Design Brief - REVISED

6310 Hazeldean Rd. **Development**

April 2024

Review of UDRP's comments received on October 6th, 2022

CONTEXT PLAN PROPOSED IN FALL 2022

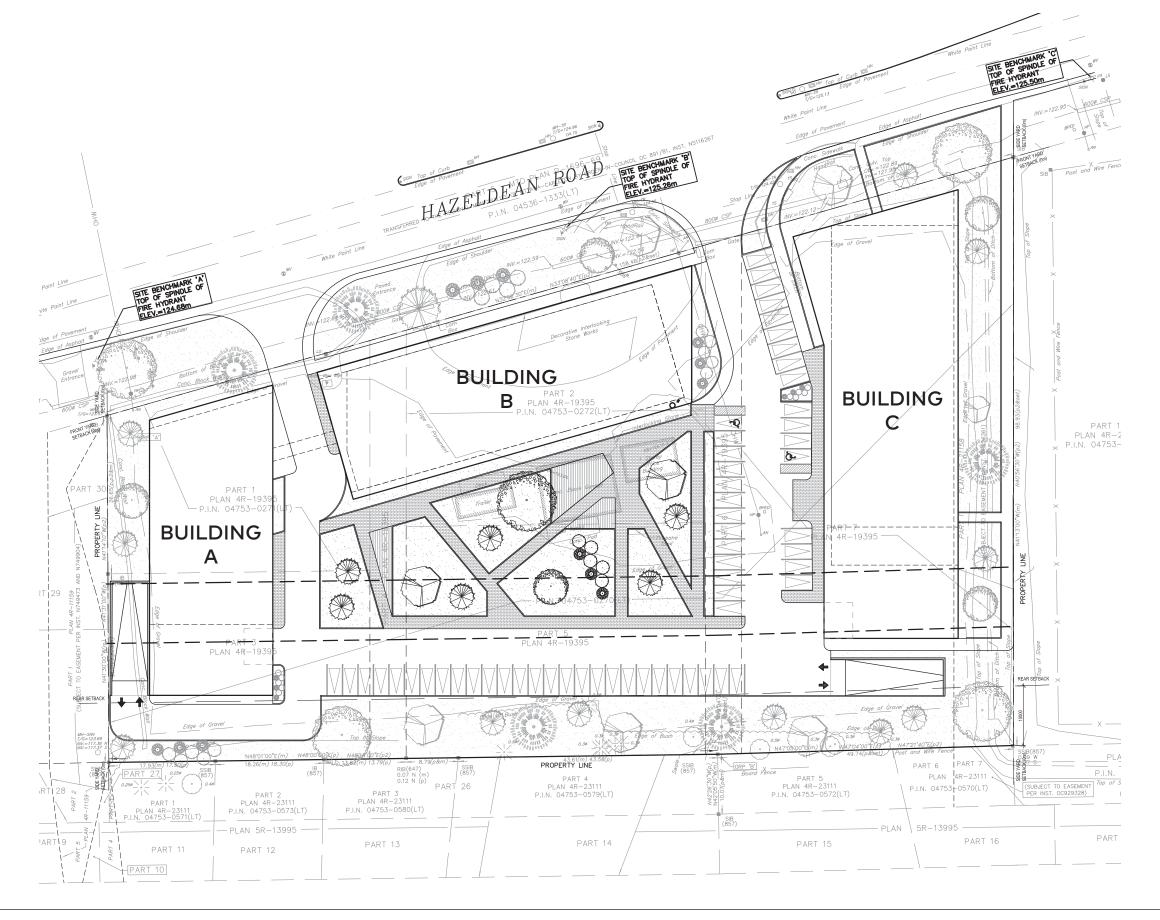
The Panel believes that the site will set a precedent in the area where a strong architectural expression and public realm vision is needed to embed the site into the greater landscape and neighbourhood context.

The Panel supports, in principle, more density on the site; however, there are more opportunities to enhance the public realm and landscaping and to build a sense of community while considering how the proposal will set a standard for the future.

At this stage of the development process, the Panel expects to see a proposal where the architecture has been resolved, is viable, will be built and become part of the neighbourhood. A more detailed proposal would enable the Panel to provide more wholesome comments and input.

The Panel expressed disappointment with the current level of resolution of the architecture.

The Panel recommends the City not grant the changes to the setbacks as the site provides enough space to accommodate the buildings while maintaining the setbacks requirements.

The Panel recommends increasing the density on Hazeldean Road and reorienting Building B to parallel the street to create an urbanized corridor. Should the building be parallel to the street, the Panel recommends connecting Buildings A and B with glazed volume. Additionally, the proponent should consider elongating the building to eliminate the north-south wing since the inside corner units of an L-shaped building have with limited access to light.

The proponent should consider relocating the drop-off area underground on the north side of Building C to provide access to all three buildings. This would open up the layby space and allow for more greenery and reconfiguration of the parking layout.

The Panel questioned the appropriateness and amount of commercial space on the ground floor, given retail may not be viable. The space could be used for residential amenities.

The Panel believes the site's configuration is dominated by parking. The proponent should develop a strong pedestrian realm proposal that accommodates bicycle parking and has a high-quality landscape with outdoor amenities and a residential character.

The Panel has concerns with the scale and massing on the site as the buildings do not reflect the neighbourhood's character and only relate to each other. The Panel recommends the proponent study the area and its architecture to establish a language that complements the neighbourhood.

The Panel notes the ground floors configurations are repeated throughout the site, and the suite plans might do not reflect the siting or architecture of the individual buildings. The proponent should consider providing a high-quality amenity at grade, as the amount of space allocated for each suite is questionable.

The proponent should consider more variety on the facades and larger glazed openings and the introduction of large family units to break up the sameness of the buildings. The proponent should also consider adding more glazing with masonry at key corners to provide amination at the ground floor level.

The Panel believes Building C should have more articulation to break up the long façade.

The proponent should consider stepping and terracing the building toward the neighbourhood to provide a more significant transition and greenery at the rear

The Panel has concerns with the parking at the rear, given the possibility of headlights spilling into neighbours' yards. The parking does not allow for an outdoor amenity area due to the limited open space. The proponent should consider eliminating parking at the rear or designing the open spaces first, before laying out the parking.

There is an opportunity to add a bosque of trees and have a wrap-around landscape adjacent to the townhouses to create a strong landscape design and to strengthen the existing buffer.

The proponent should focus on site sustainability by implementing stormwater management and providing opportunities within the landscape to integrate utilities.

Acknowledged, a new updated concept has been prepared that includes a strong contemporary architectural expression. This new proposal includes a stronger ground plane experience with ground floor accessible units and strong active entrances for the two buildings proposed.

Agree, the new concept provides a stronger presence to Hazeldean while providing a strong transition to the neighbouring properties to the south. Though a future ROW is considered in the site plan placement of the buildings, we anticipated that this new street scape will eventually include for stronger pedestrian sidewalks, a bike path and significant green space that is included in this proposal.

Acknowledged, the team has included Figurr Architects who have prepared a more detailed exploration of the development, including enhanced urban design experiences, building massings and aesthetics, as well as how the buildings reflect the existing urban conditions along Hazeldean Rd. and the neighbouring properties.

Acknowledged, responded to in previous comment

Acknowledged, the site planning in the new proposal respects all required setbacks.

Acknowledged, a new proposal by Figurr Architects new proposes a two building solution with a strong street face along Hazeldean. Massings and heights have been carefully developed to contribute to a strong main street façade, an appropriate transition to neighboring properties, as well as considering sun and shading of the massing against this and other neighboring sites.

Acknowledged, a new two building proposal has been prepared with a stronger centralized drop off for both buildings under building 1. Parking has now been concentrated within a two storey parkade structure (and u/g garage) that has been clad with light coloured panels and vegetated screens.

Acknowledged, commercial no longer part of new updated proposal.

Acknowledged, at grade parking has been greatly minimized to provide mostly for visitors. A new 2 storey parkade (and u/g garage) will house remaining parking. A large amenity terrace will be located above the garage parkade.

Acknowledged, this new proposal has a stronger contemporary language. This area of the city does NOT have a specific and strong existing building language. The area is dominated by a mix match of suburban single family homes, industrial lands and typical suburban commercial strip centres. We do not believe that these are great examples to draw from and believe that the new concept – through thoughtful massing, proper transitions, and enhanced green buffer areas - provides a strong refined aesthetic that actually responds to enhancing urban planes.

Acknowledged, the new proposal has been properly explored to include proper ground floor programming for these types of buildings. Programs have been located to enhance the public realm with clean open and active entrances and amenity areas along Hazeldean. Bike rooms, move-in rooms and access to other supportive programs have been properly located to further support the concept.

Acknowledged, the concept attempts to address these concerns with a strong contemporary design as also previously mentioned in past comments. Larger units will be part of the project but a final unit typology will be part of a future Site Plan Control submission.

Acknowledged, please see new proposed concept that has a two building solution with varying setbacks and material explorations.

Acknowledged, new concept has been primarily developed by exploring that major aspect along the neighbouring properties.

Acknowledged, a new enclosed parking structure integrated with the buildings has been proposed. This greatly reduces the at grade parking. Project will ensure a minimum fence line and significant 10m green buffer zone between the rear lot lines and any building or parking area.

Acknowledged, please see new concept that greatly increases the use of green landscaping and significant buffer zones.

Acknowledged, as the concept now evolves, this will be part of the proposed project.
